MEMORANDUM

TO: Historic Preservation Commissioners
FROM: Erin Schumacher, AICP, Senior Planner
RE: Review of Amendment to COFA-5-16-9658 – Lot 26
DATE: 10/5/16
CC: Heather Colin, AICP, Director of Growth Management
Kevin Icard, AICP, Planning & Community Development Manager

Myers Residence

Myers Residence Plans

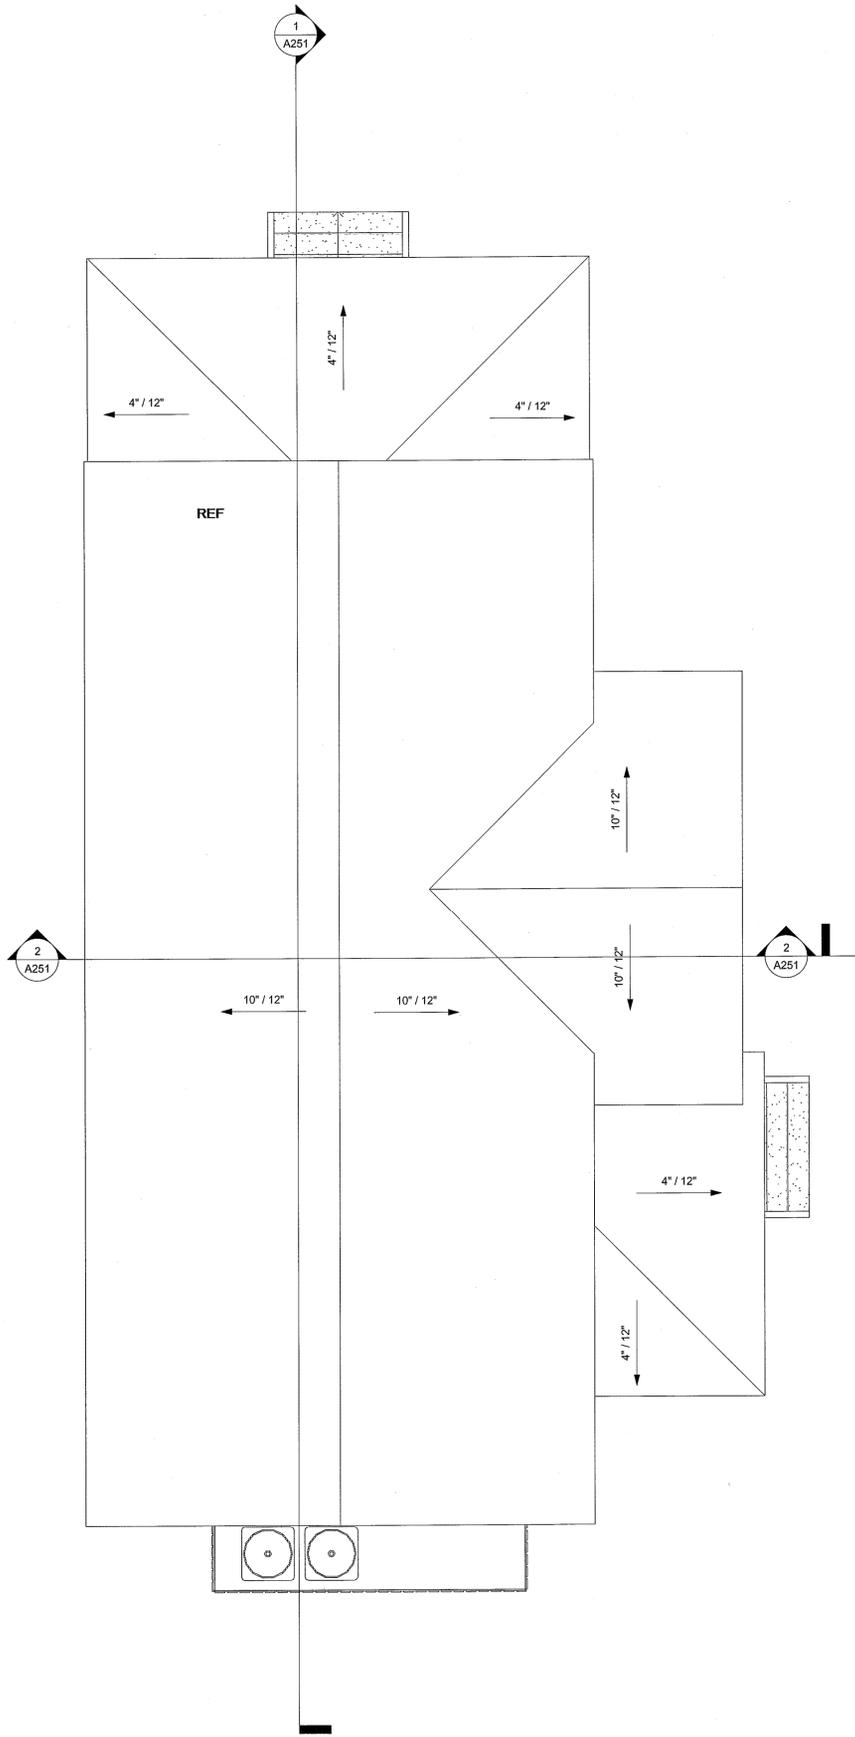
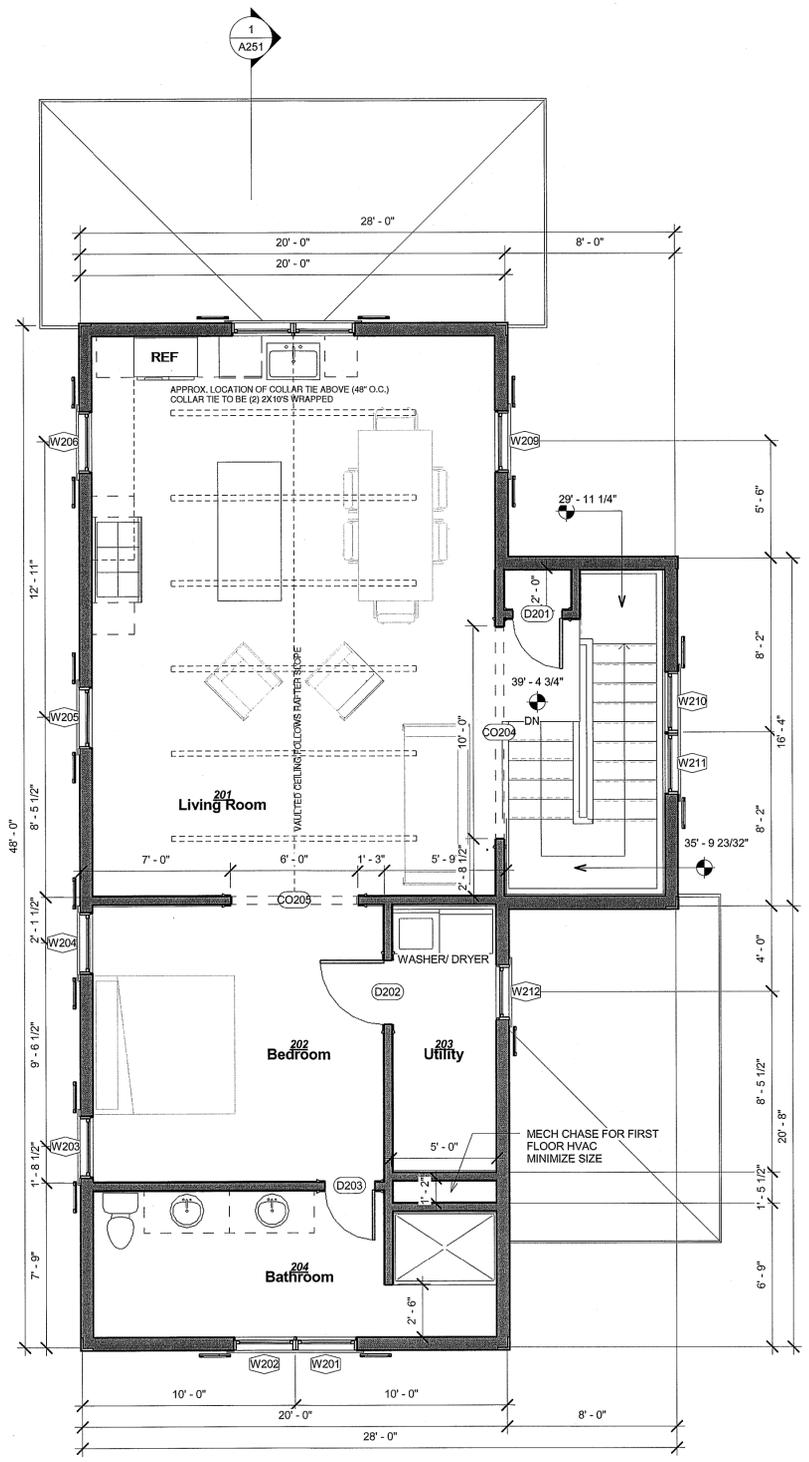
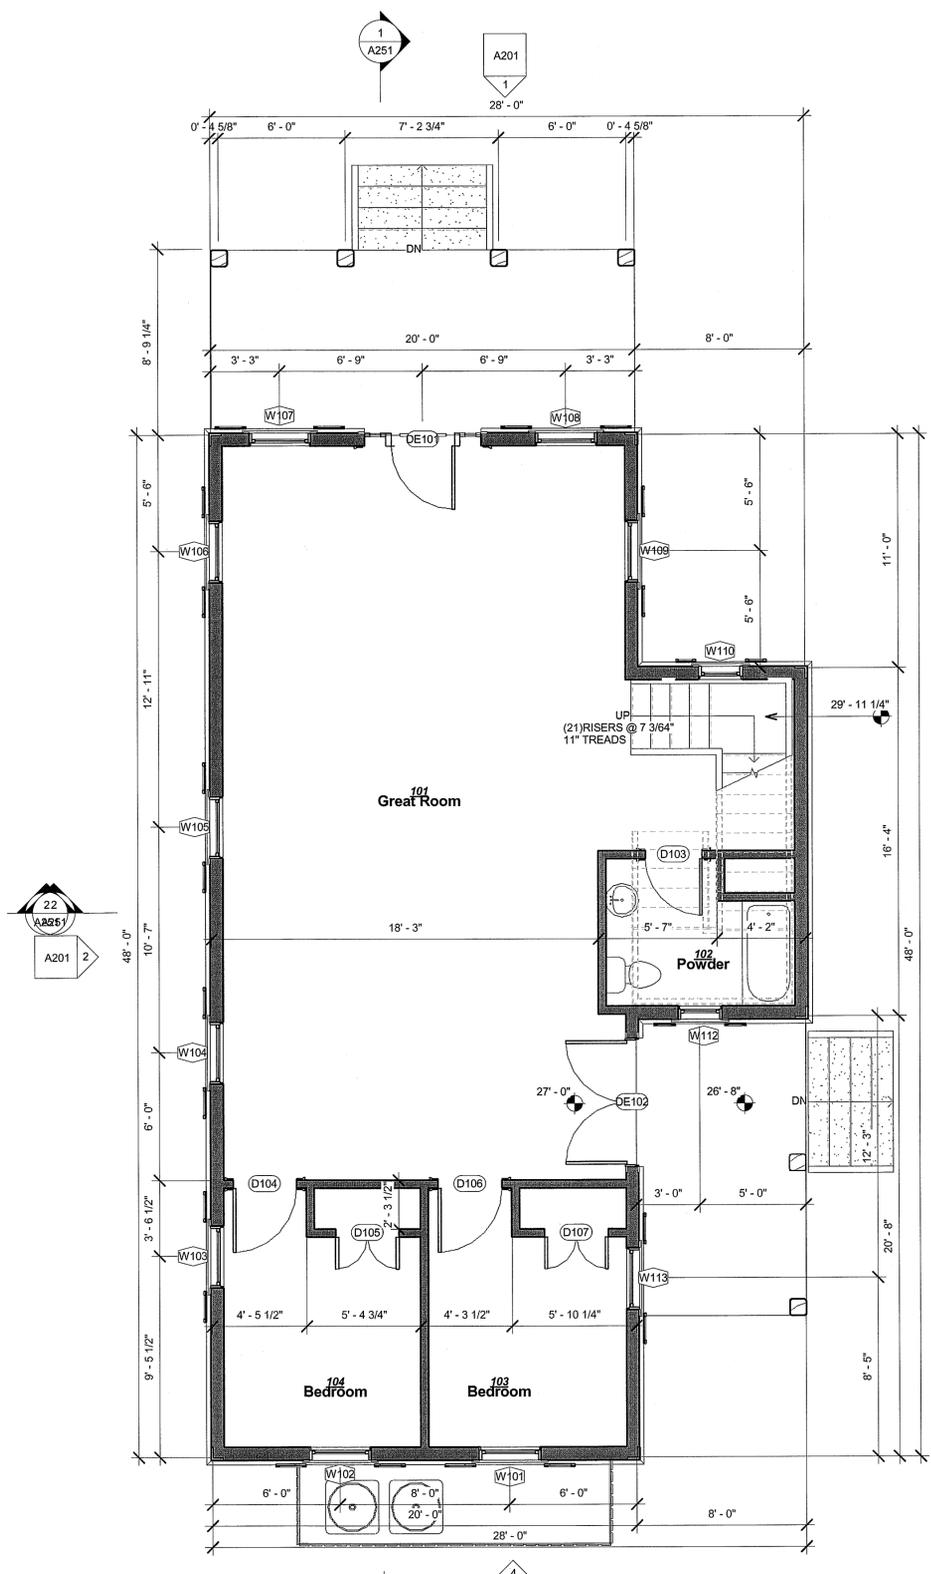
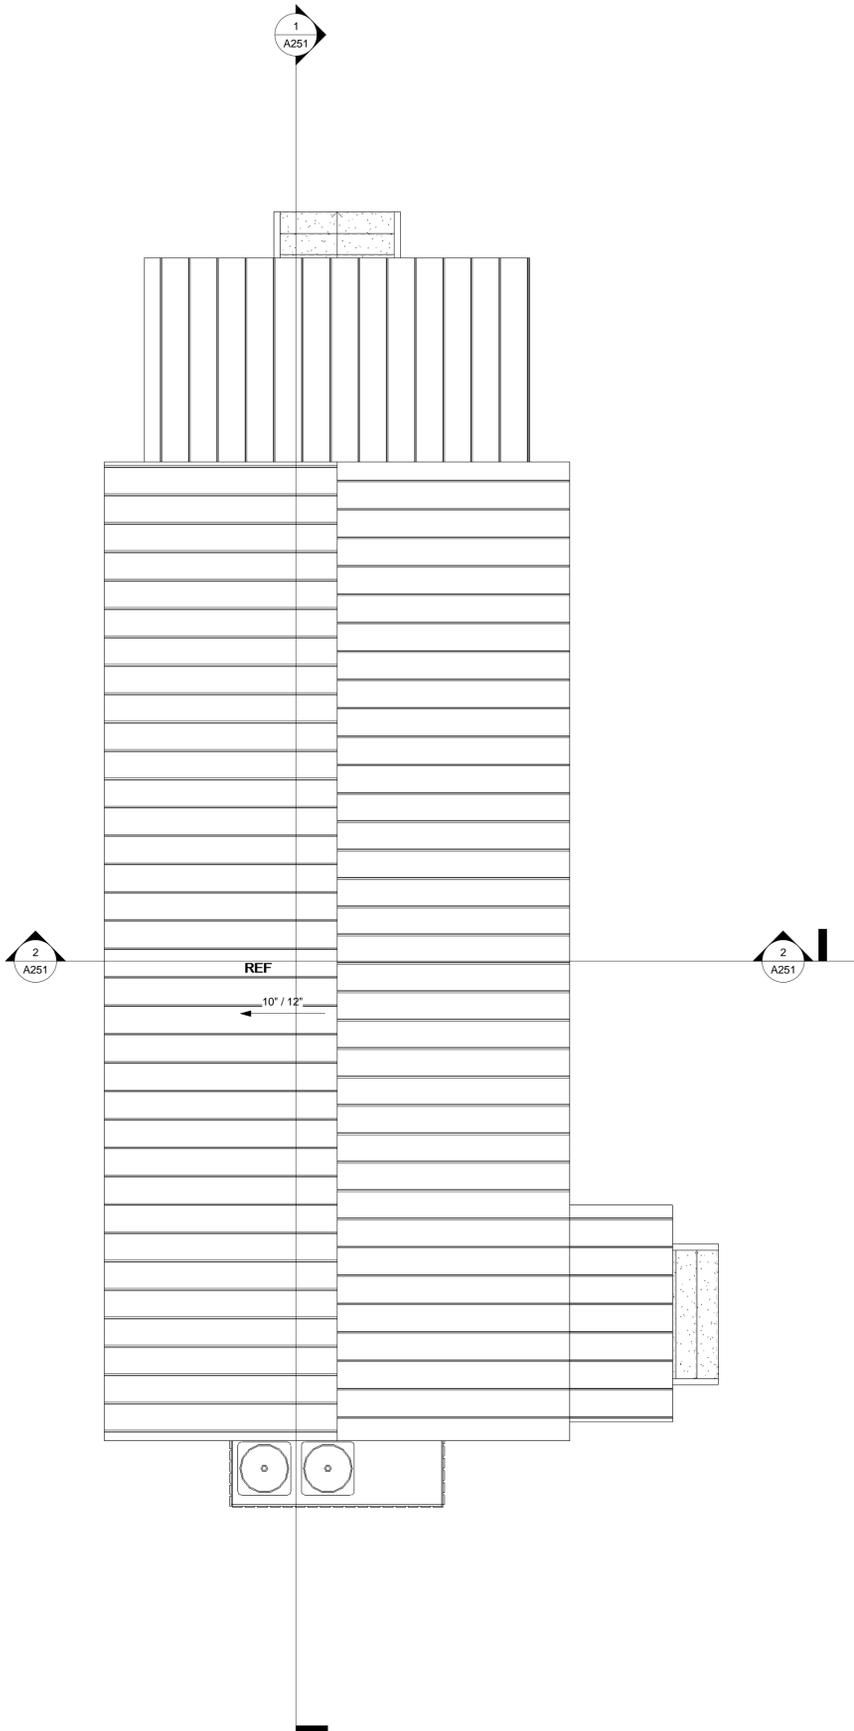
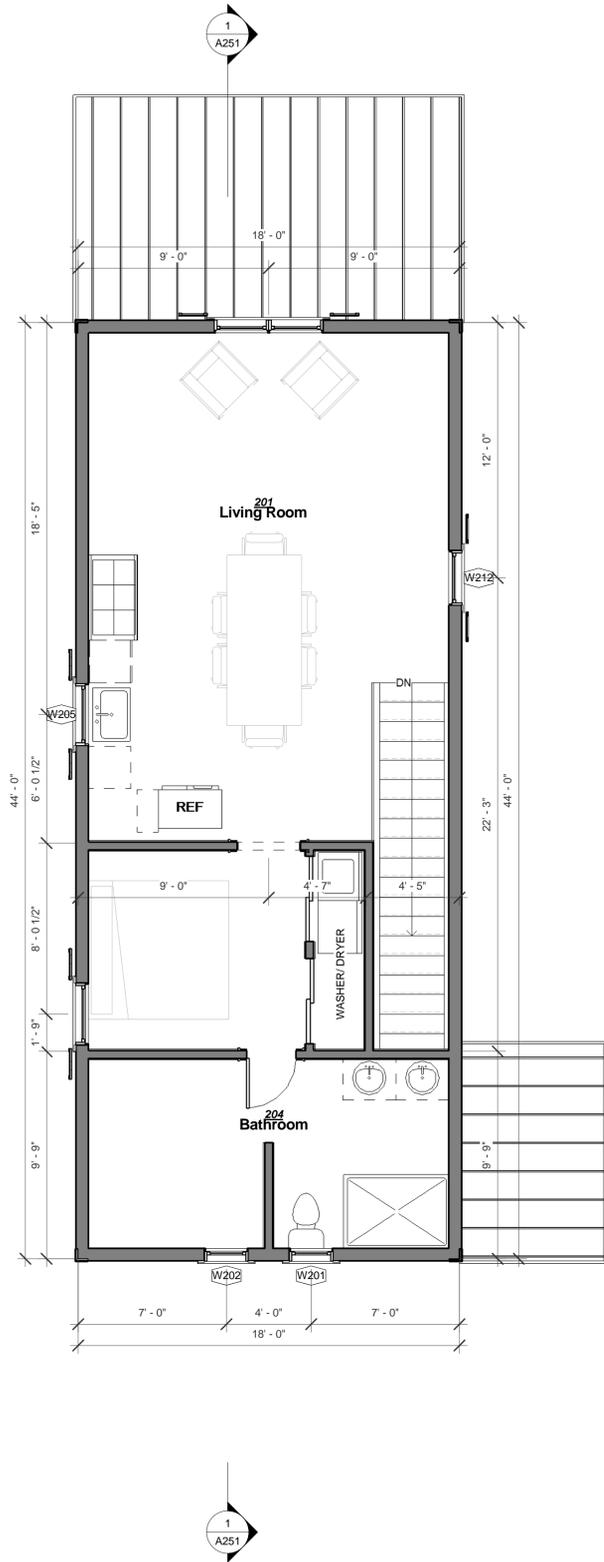
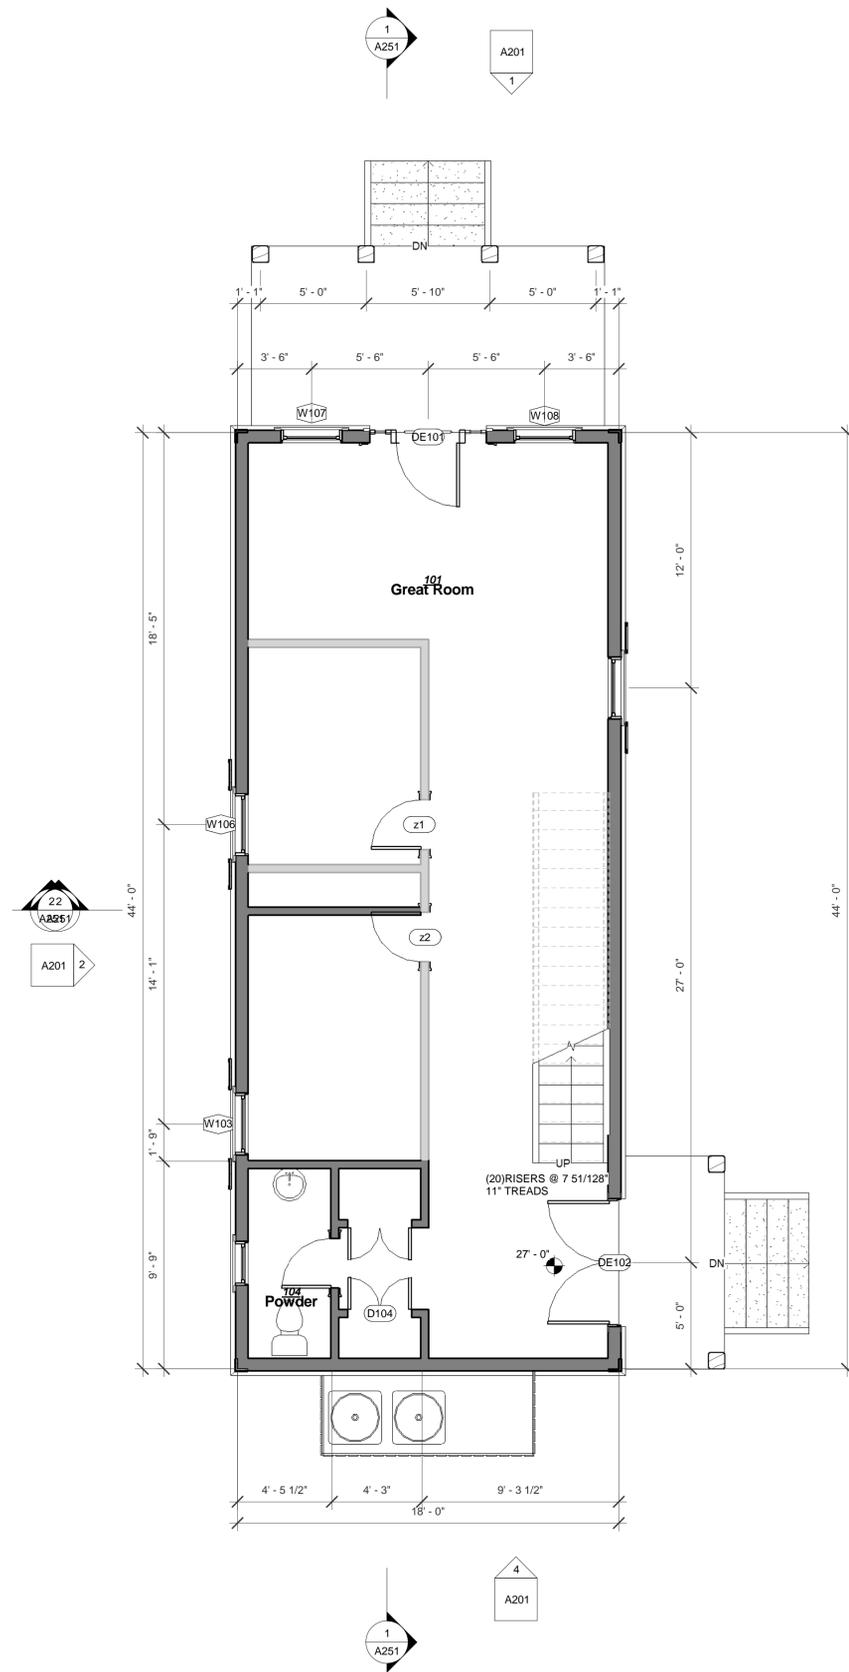
1. Revise the floor plan to integrate the stair inside the main gabled structure and revise the Left Elevation to accommodate this change as well as other minor modifications to window locations and detailing throughout the building.
